**Re: Toyota Temporary Parking Lot, Grading and Drainage Plan
Certification dated –no date-
Engineer's Stamp Date 4-13-15 (C18D083)**

**Re: Toyota Temporary Parking Lot, Grading and Drainage Plan
Engineer's Stamp Date 4-13-15 (C18D083)**

**Re: Toyota Temporary Parking Lot, Grading and Drainage Plan
Engineer's Stamp Date 2-24-15 (C18D083)**

**RE: American Toyota – Temporary Lot (File: C18D012)
Conceptual Grading and Drainage Plan, Engineer's Stamp Date 1-9-15**

ENGINEER'S SEAL	AMERICAN TOYOTA TEMPORARY CONSTRUCTION YARD	DATE 2-25-13	SHEET # 21403
GRAPHIC SCALE	GRADING AND DRAINAGE PLAN	Ro Grande Engineering 1000 10th Ave N.E. Albuquerque, NM 87106	JOB # 21403

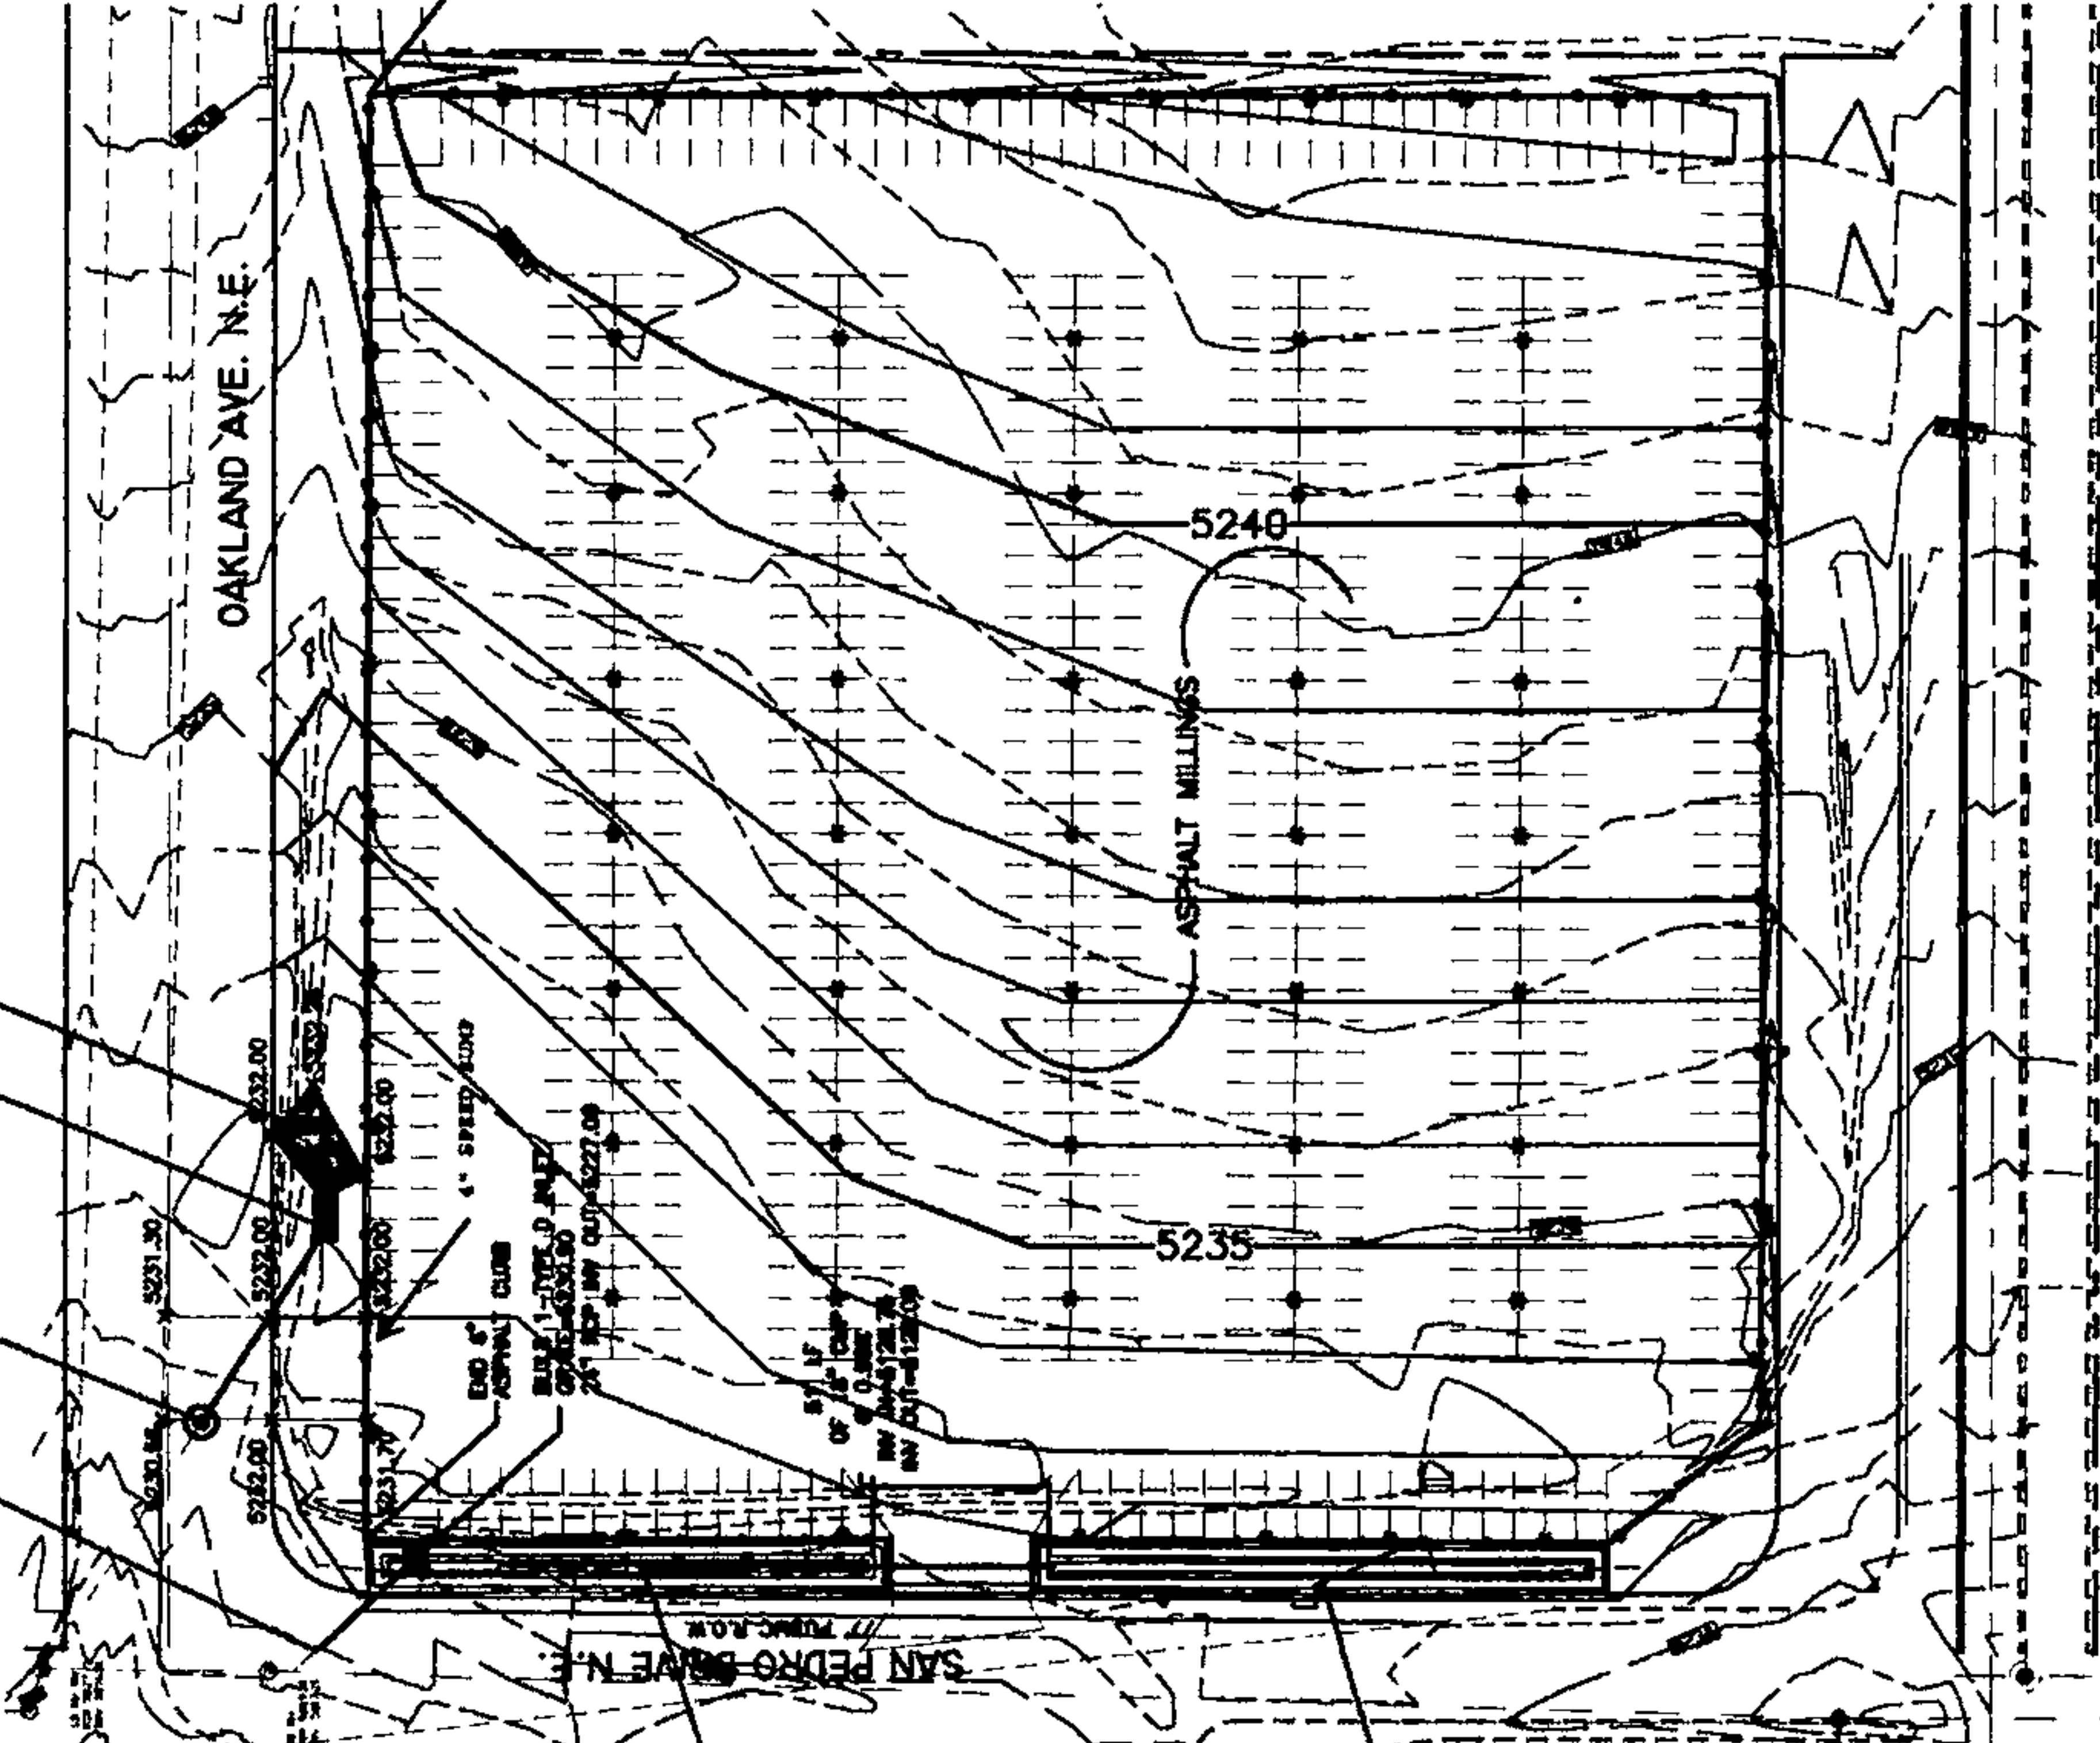
1. It appears an asphalt curb is needed to force the water into the first flush pond. In addition erosion protection is required where concentrated flows enter the ponds

7 2. Work within the right of way requires a work order
We have added this note to the plan set.

We have added the curb and called for rip rap to be placed at the location concentrated flows enter the ponds.

ENGINEER'S SEAL DAVID SOULE P.E. #14322	AMERICAN TOYOTA CONCEPTUAL GRADING AND DRAINAGE PLAN Rio Grande Engineering 1004 CENTRAL AVENUE NE SUITE 200 ALBUQUERQUE, NM 87106 (505) 262-0000	DRAWN BY WCBU DATE 2-25-15 SHEET # JOB # 21403
---	---	---

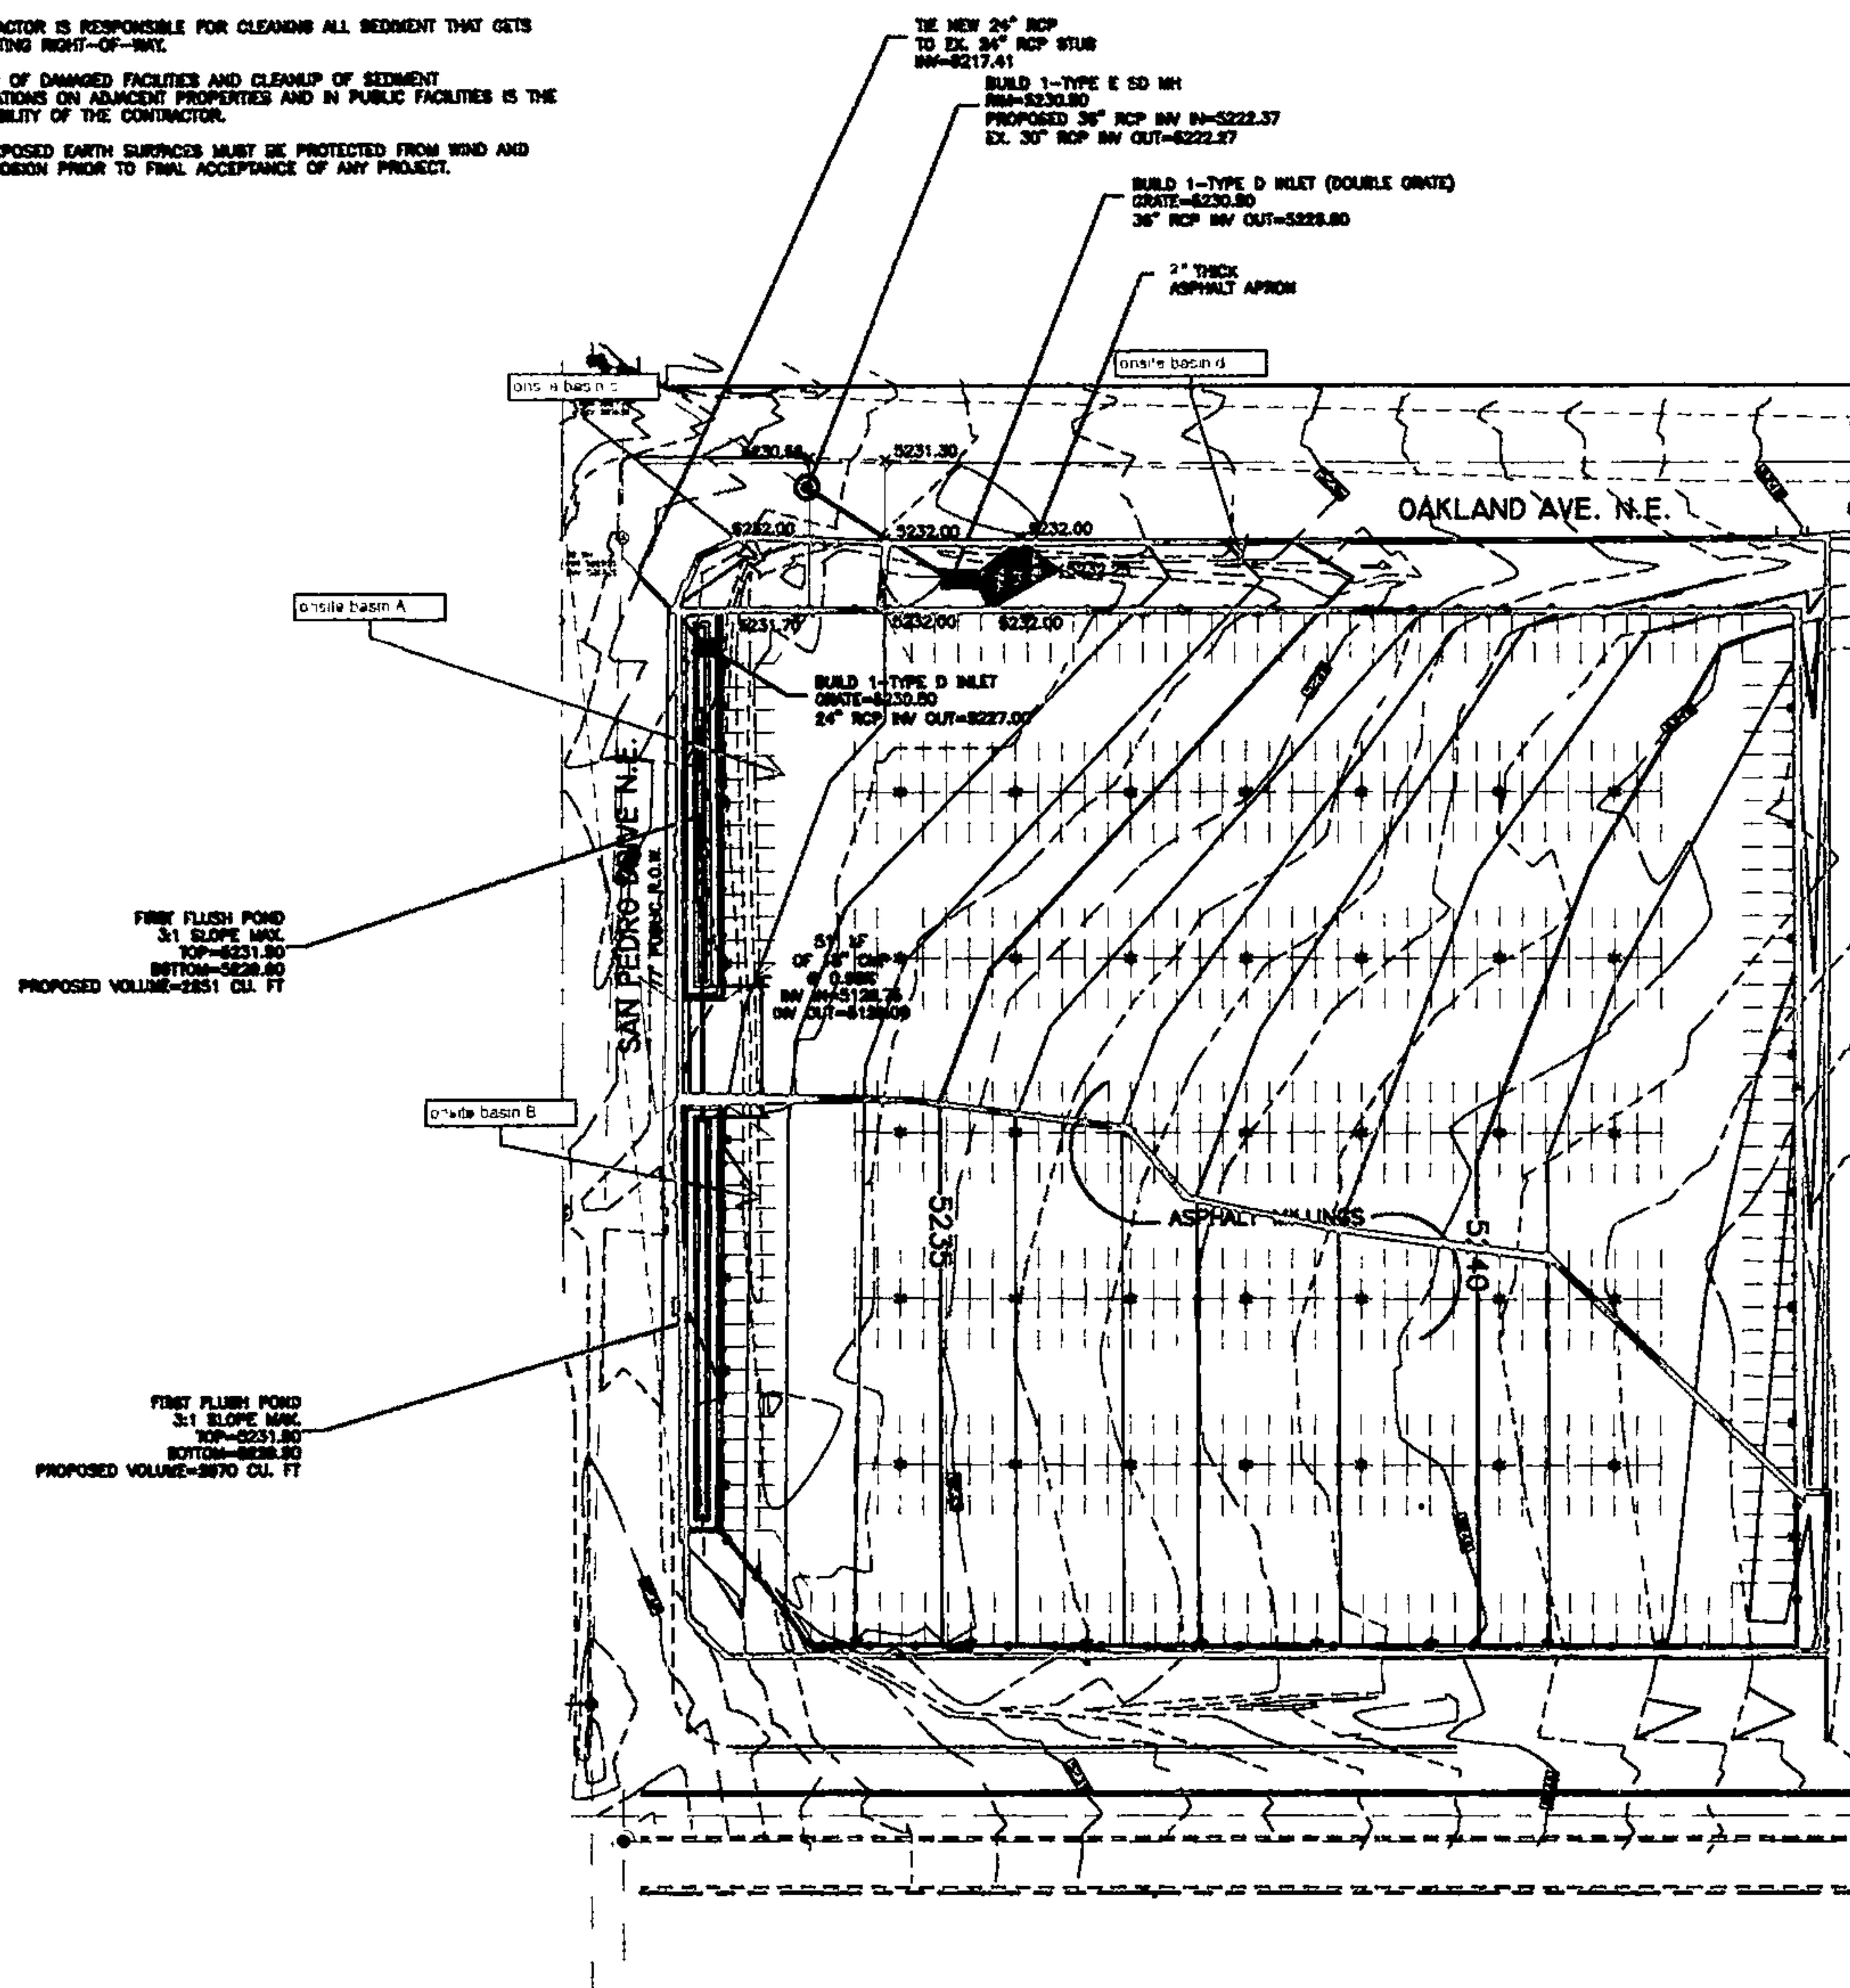
2. Upland flows were based upon developed due to master plan requirements of the future development, use existing conditions.

3. Basin 1a needs to be modified to account for parked cars.

5. Lot appears to have 2 basins; the pond connection pipe needs a slope.

6. Update sump calculations. How will emergency over flow be handled.

We have shown existing conditions, the entire area does not drain to this site. A portion of the upland basin goes out of an existing driveway to alameda. This shown on the upland basin map

The land treatment is millings and gravel. Therefore land treatment C. We have increased the land treatment to 40% D, which accounts for cars and consolidation of drive isles, I am not sure it is appropriate to consider the land a car is parked on as 100% impervious. The site sheet flows and water flows under the cars and infiltration occurs. We feel our land treatment types are appropriate and conservative.

We have added an onsite basin map and the site contains 4 basins. We have adjusted the grades such that the flow passing thru the pipe is less than its capacity. A pipe calculation has been added

We have updated the orifice calculation for the modified grates. We have a double grate with a 1.5' head. In the event of clogging the flow will continue to flow into San Pedro as it currently does.

Weighted E Method
AMERICAN TOYOTA TEMPORARY YARD

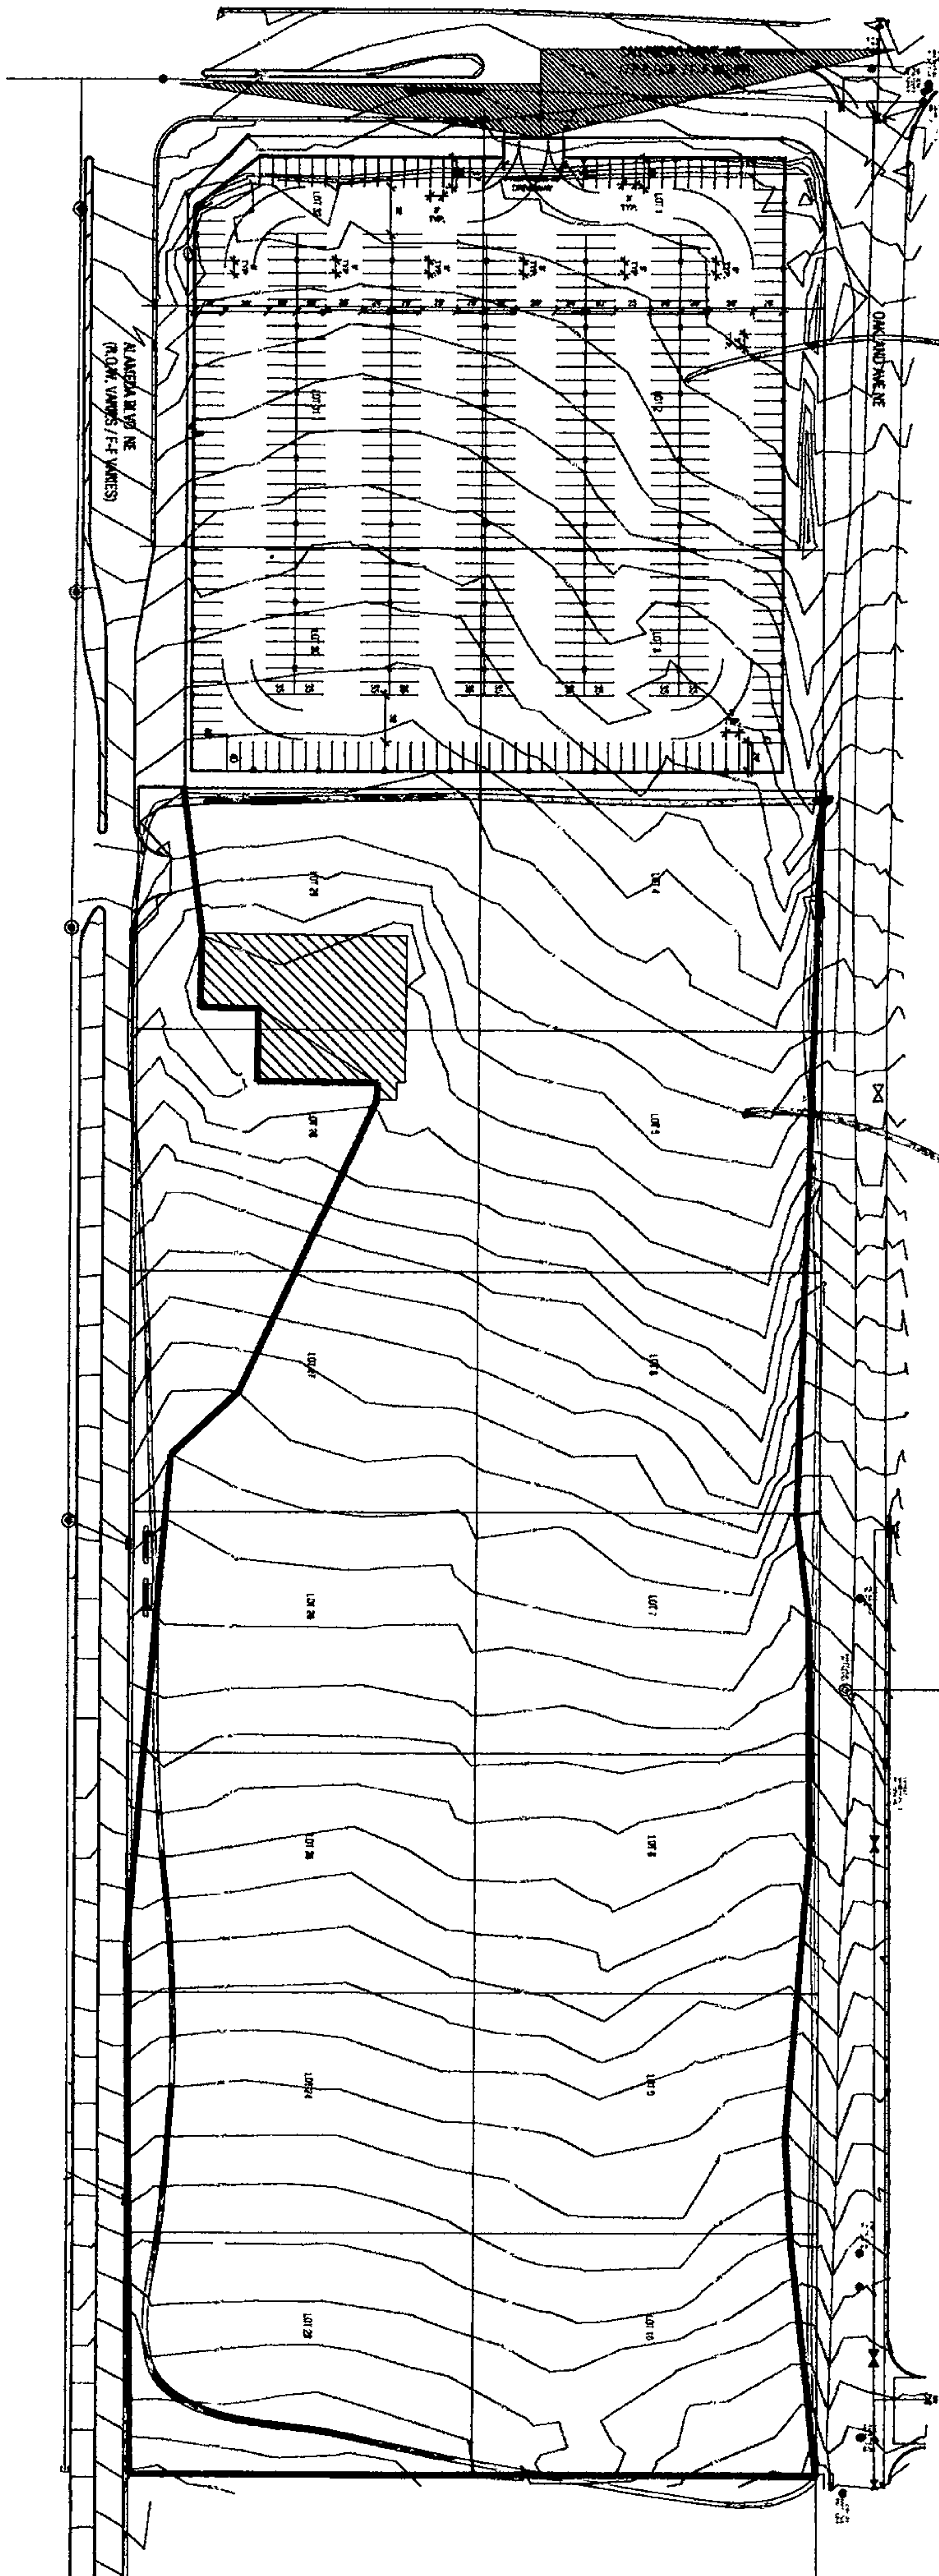
show how
Grate area
calc'd.

convert half to D to account for concentrated flows from cars.
